REVISED RESPONSE TO REQUEST FOR ADDITIONAL INFORMATION**APR1400 Design Certification****Korea Electric Power Corporation / Korea Hydro & Nuclear Power Co., LTD****Docket No. 52-046**

RAI No.: 398-8457

SRP Section: 15.06.05 – Loss of Coolant Accidents Resulting From Spectrum of Postulated Piping Breaks Within the Reactor Coolant Pressure Boundary

Question No. 15.06.05-5

Figure 1 Core flush by hot side injection

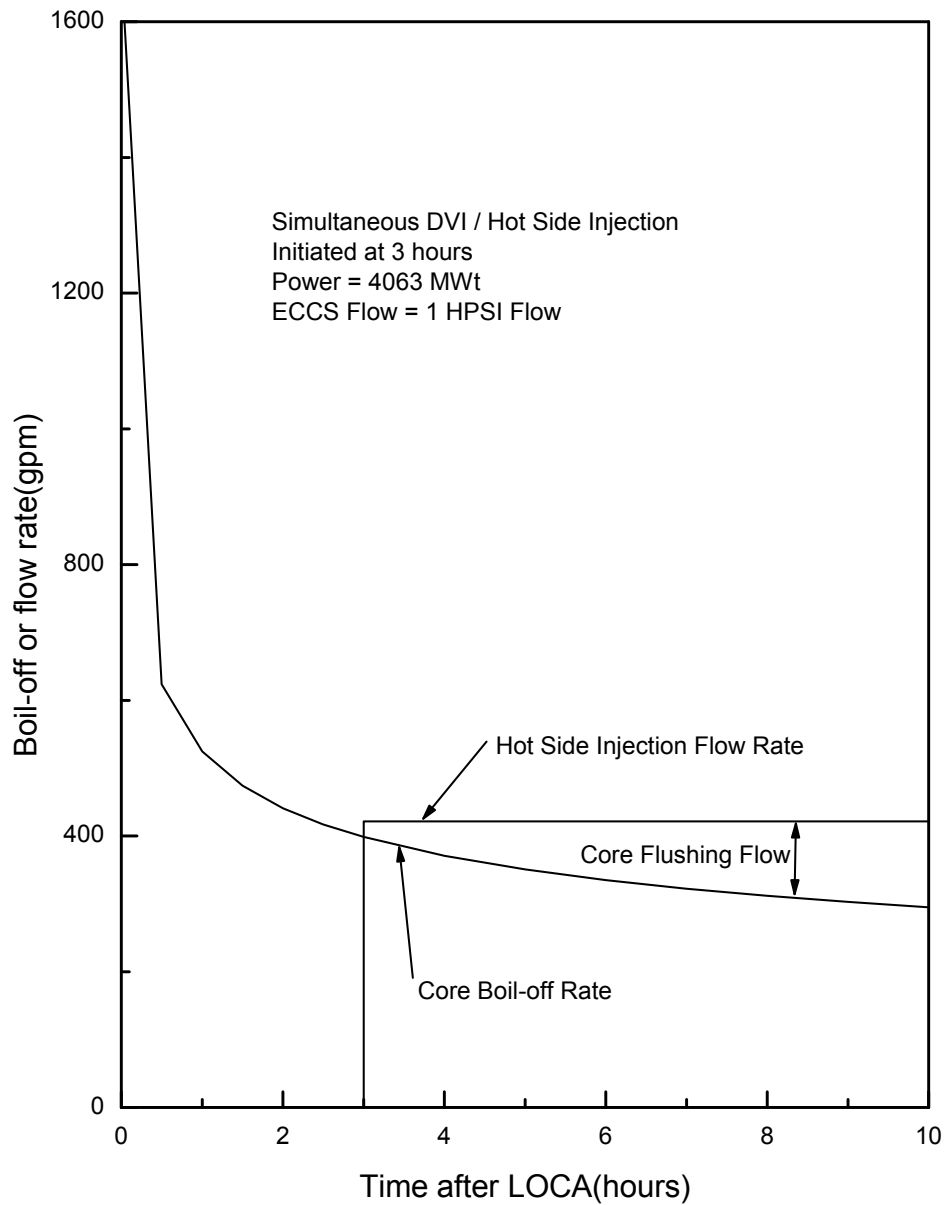
2. The analysis does not appear to account for reduced injection flow during the switchover to hot leg injection at 3 hours (Section 3.5.4). Is there a reduced flow during this transition period and how is it addressed in the calculation?

The injection flow is not considered to decrease during the switchover to hot leg injection. Instead, the injection flow is assumed conservatively. The flushing flow rate is calculated by hot side SI injection flow and core boil off rate as shown in Fig.1. Even though 2 SI pumps actuate during the switch over period, it is assumed that 4/10 of the total flow from a single SI pump enters the reactor vessel from the hot leg and all of the decay heat from the core boils off liquid. At 3 hours, core flushing flow is decreased to 23 gpm. After 3 hours, as the core boil off rate has decreased, the core flushing flow has increased. The flushing flow rate is used to compute the boric acid concentration in the core.

Figure 5. Inner Vessel Boric Acid Concentration vs. Time

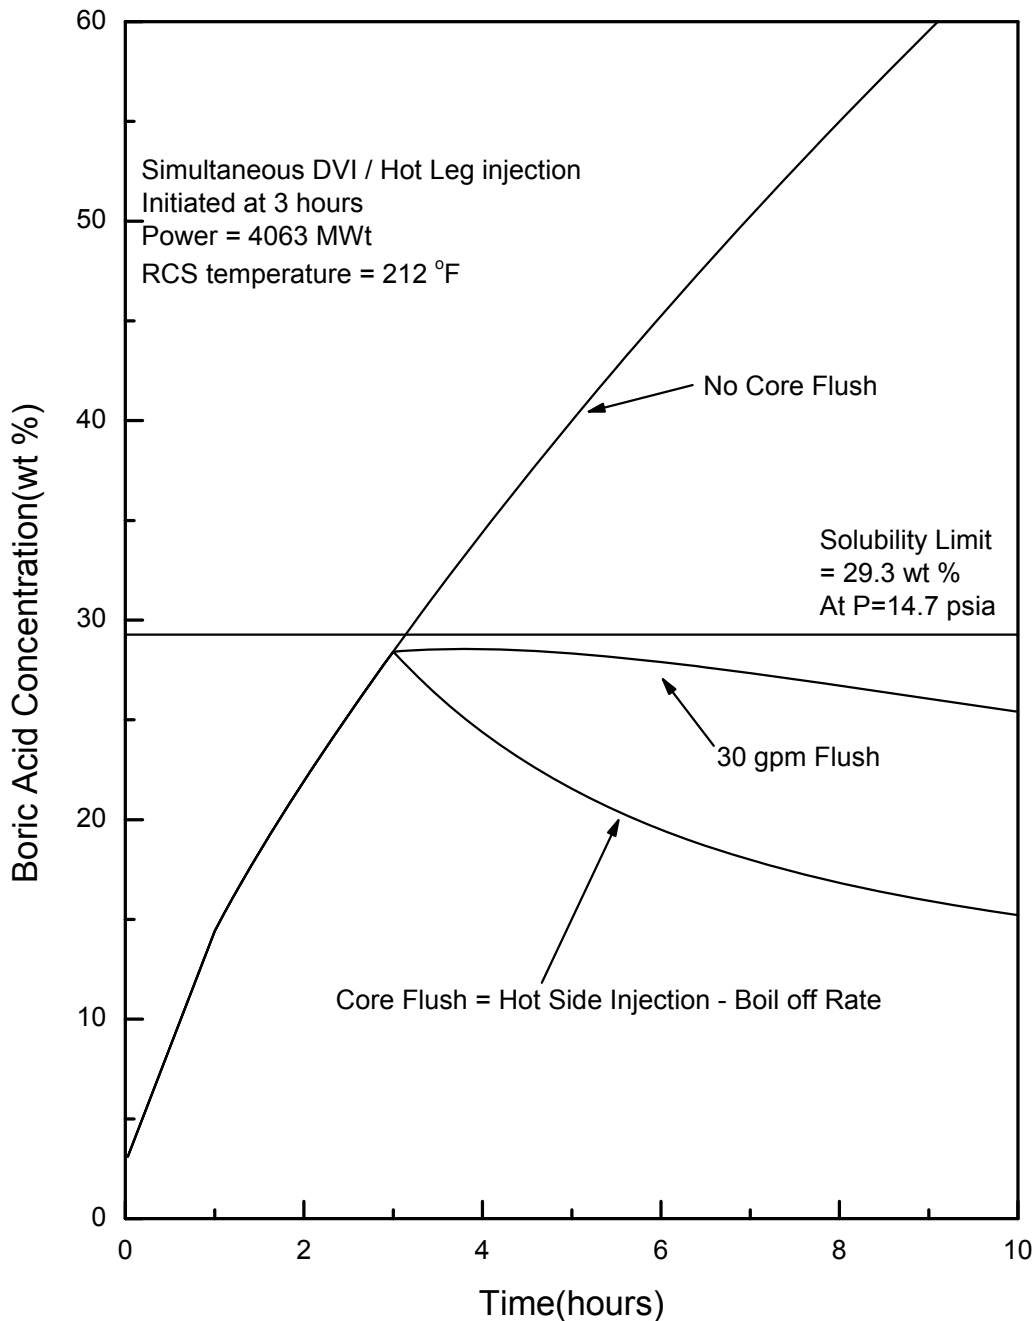
13. Figure 4-3 shows the buildup of boric acid concentration which depends on the boiloff rate and appears to be independent of break size? For smaller breaks where natural circulation is mixing the coolant, the switch to hot leg injection could possibly hinder the natural circulation by introducing cold liquid into the hot side of the natural circulation loop. How does the approach used address this possibility?

The double ended cold leg break size is the limiting break for long term boric acid accumulation in the inner vessel region, because the largest amount of coolant with high boron concentration is added to the inner vessel from SITs and SI pumps. Therefore, only the double ended cold leg break size is considered to calculate boric acid concentration by the BORON code. Thus, the boric acid concentration for the double ended cold leg break size is depicted in Figure5.

The mixing volume for computing the boric acid concentration is changed to include the additional volume from the top of the core to the top of the hot leg piping at the RV outlet nozzles. If the water level in the inner vessel is higher than the top of hot leg, boron precipitation is not a concern. Natural circulation is not considered in the BORON code because natural circulation begins when injected water refills to the top of the steam generators, in the case of smaller break sizes.

Even though the switch to hot leg injection could possibly hinder the natural circulation by cold water; boron precipitation does not occur around the top of the core. Thus natural circulation is not addressed in the BORON code.

Figure 6. RCS Pressure after Refill vs. Break Area

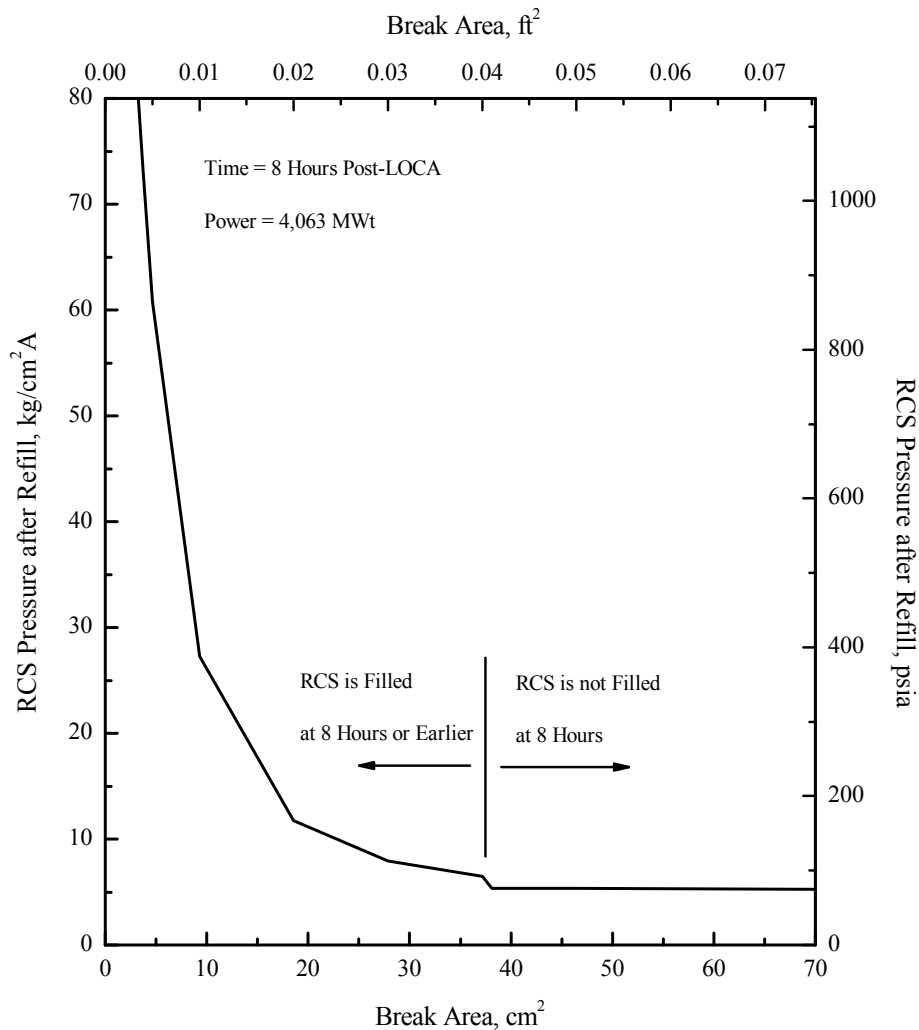
14. In the CENPD-254 methodology, the maximum break size for the small break analysis is determined by the auxiliary feedwater capacity. There is no mention of auxiliary feedwater capacity in the technical report. How was the upper limit size determined for the small break?

The decision time at which the operator decide whether to use the large break procedure or the small break procedure in order to continue the cooldown of the RCS. This time (8hr) is determined between the earliest time at which the SDC entry conditions can be achieved, and the latest time for which auxiliary feedwater can be assured to be available.

In order for the SDC system to be used to remove heat from the RCS, there must be sufficient liquid in the hot leg from which it takes suction. If RCS is refilled before the decision point time, the break case is assured of having sufficient coolant in the RCS to use the SDC system. Thus, the decision time determines the upper limit size of small break for which the SDC system can be used. This break size is 0.04 ft² as is shown in Figure 6 below.

The NATFLOW code is used to calculate the SDC entry time and the CEPAC code is used to calculate the exhausting time of auxiliary feedwater. Finally, the refill time of RCS is calculated by CELDA code.
